## ASSESSMENT REPORT

### Section 75W

#### Settlers Ridge Concept Plan, Kempsey Local Government Area MP 10\_0103 MOD 1

**Figure 3: Approved Layout**

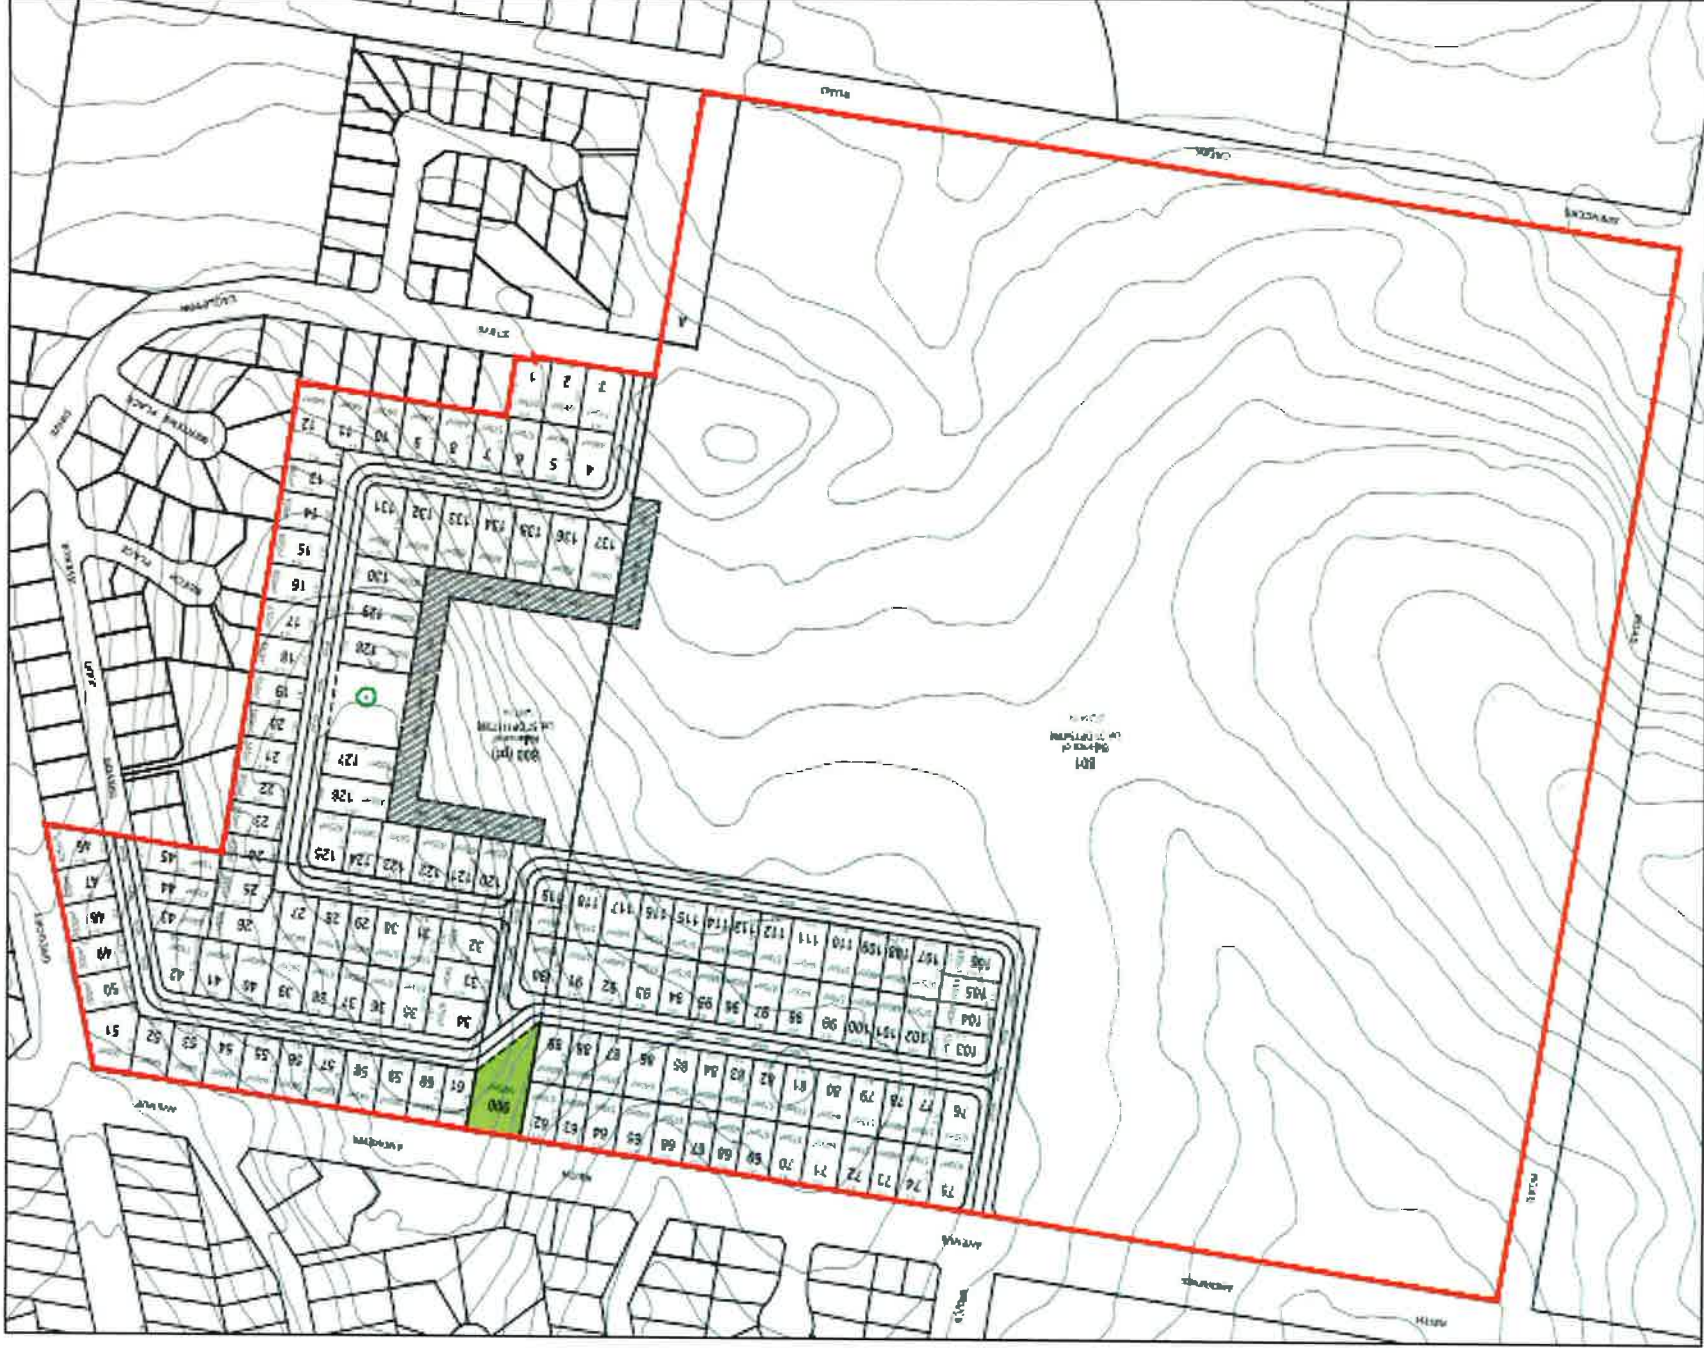
The modification request seeks approval to revise the subdivision layout to:

- remove eight lots that were not approved due to bushfire safety concerns;
- increase the total number of residential lots from 137 to 138 lots;
- reconfigure the internal road network and add a new connection to Keith Andrews Avenue; and
- consolidate the public open space and the Aboriginal scarred tree at one location.

The key changes to the approved plan of subdivision are shown in **Figure 3** and **Figure 4** overleaf.

The Department has assessed the changes to the subdivision layout and has concluded the proposed modifications are acceptable for the following reasons:

- the revised subdivision layout addresses the bushfire safety requirements of Term B2 and the public open space requirements of Term B3;
- the RFS has advised the proposed road network and APZs comply with the requirements of PBP 2006; and
- Council has confirmed that deficiencies in public open space can be addressed by way of a section 94 contribution at the development application stage.

Accordingly, the proposed modifications to the subdivision layout are supported.
